**Subject:** Moscow Renewable Energy Project

**RE: Proposed Moscow Renewable Energy Project, Proposed Wind and Solar Generation Facility, Moscow and Caratunk; Threatened, and Endangered Plants and Rare or Exemplary Natural Community Clearance Determination**

Maine Natural Areas Program, July 2020

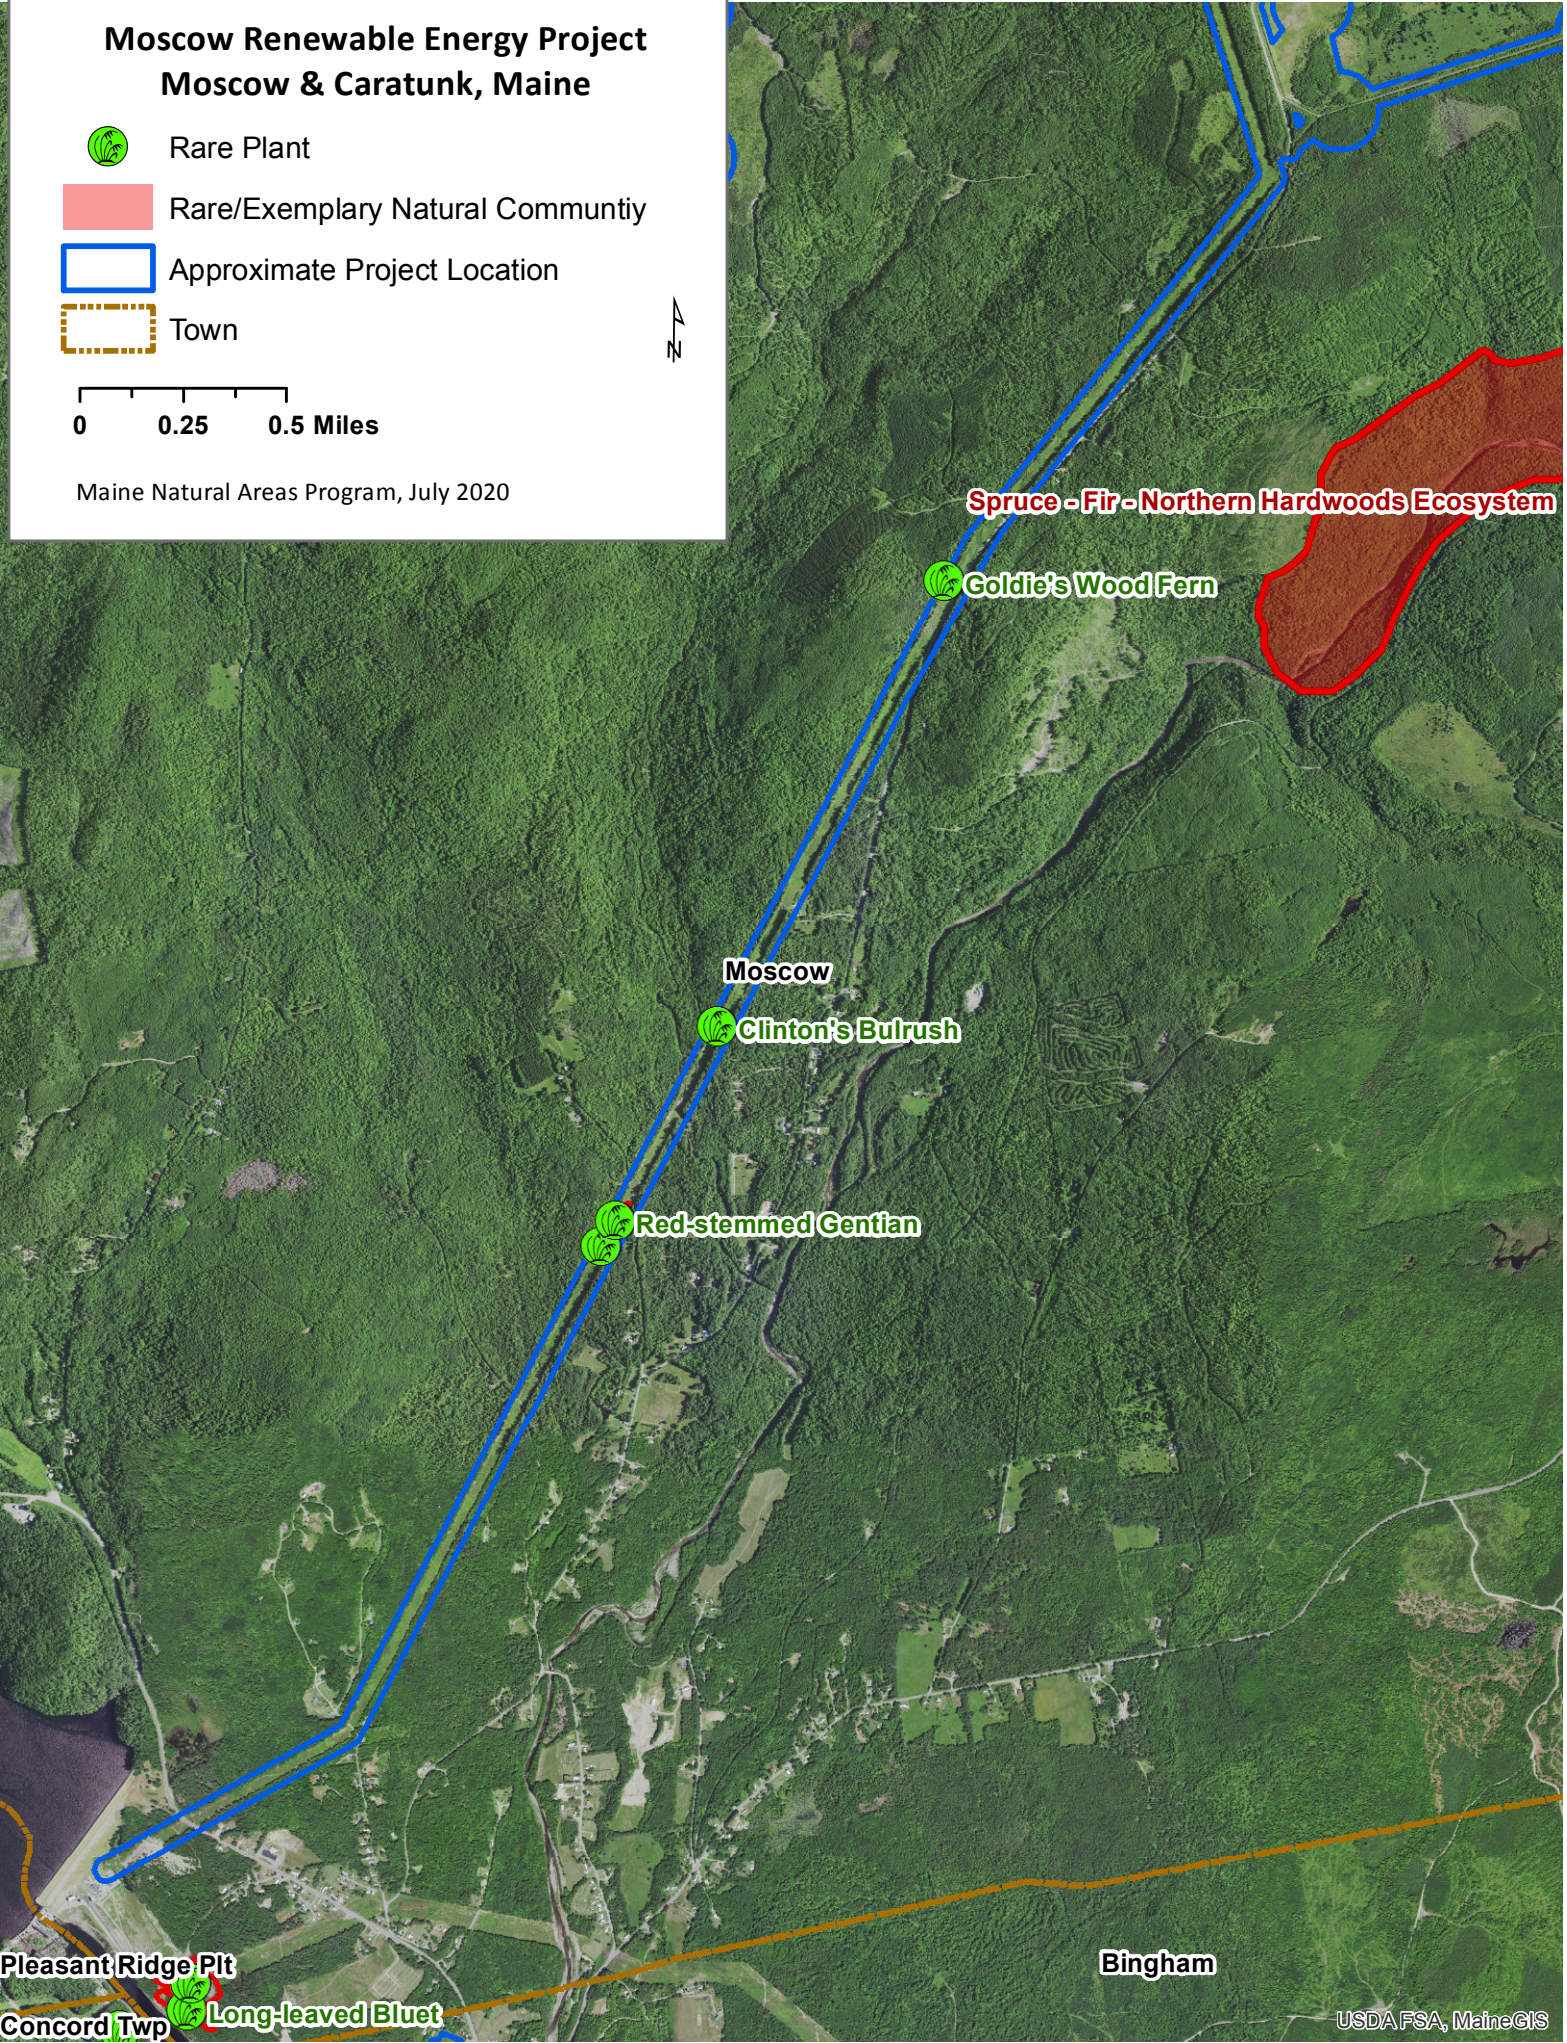
According to the information currently in our Biological and Conservation Data System files, the powerline right-of-way intersects with three rare plant species. Please see the table below and attached map and factsheets for more information about these species. If there is to be any additional clearing or new infrastructure associated with the right-of-way, MNAP requests a more detailed site plan and a site visit so that we may better comment on how the proposed activities may affect these rare plants at this location.
